RE: Change in Point of Diversion Water Right, File No 13141

DWR FIELD OFFICE APPLICATION FOR APPROVAL TO CHANGE THE PLACE OF USE AND/OR THE POINT OF DIVERSION

GMD3 Change Review

13141 PD Change Review

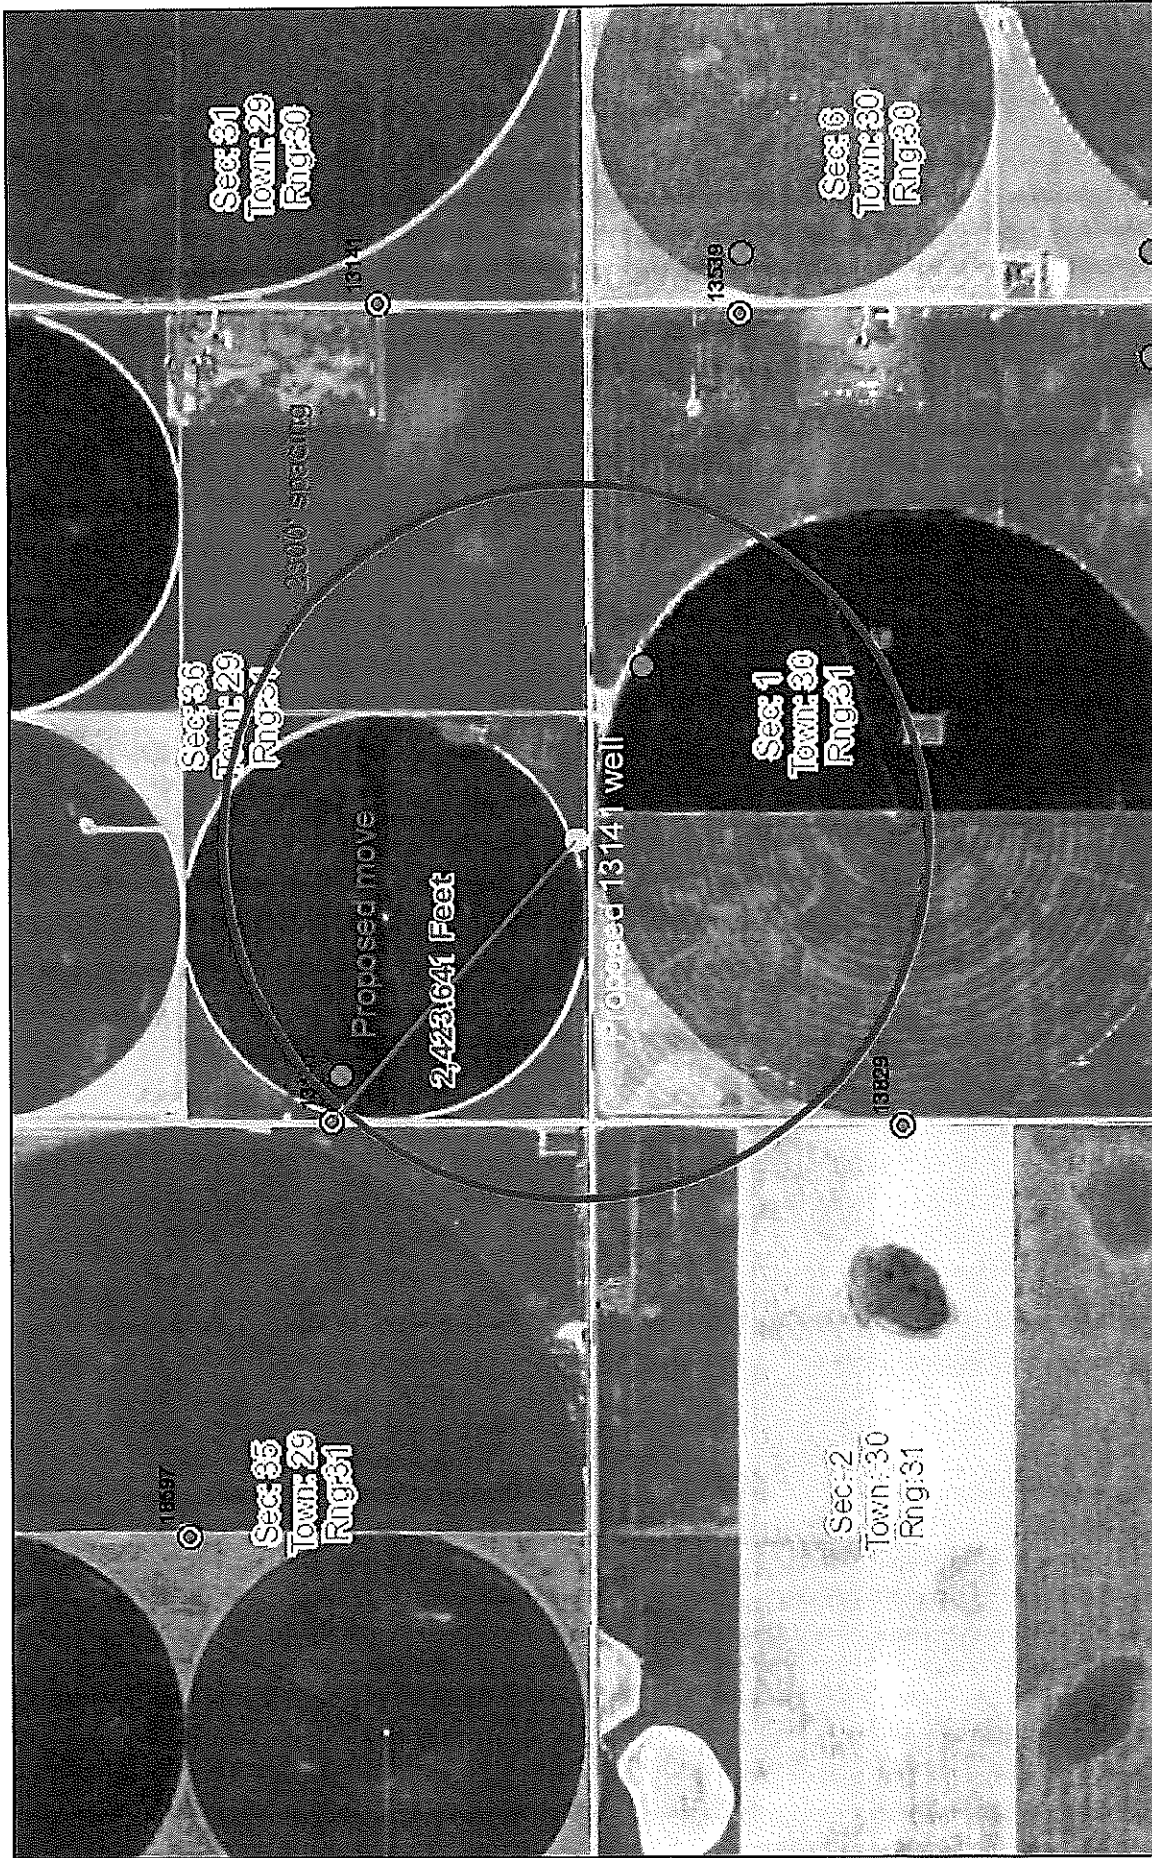
ft. North	ft. West	
Authorized PD	1915	5245	Sect. 36-29-31
Proposed PD	48	3408	
Difference	1867 S	1837 E	
$a^2 + b^2 = c^2$	3485689	3374569	2619.209 foot move SE

Neighboring certified well(s) notified: No wells within half mile

Domestic well(s) notified: None in the area of concern in use

Spacing MET

Final Recommendation: After review of all available data, it appears the area rules are met. Staff therefore recommends approval of the application.
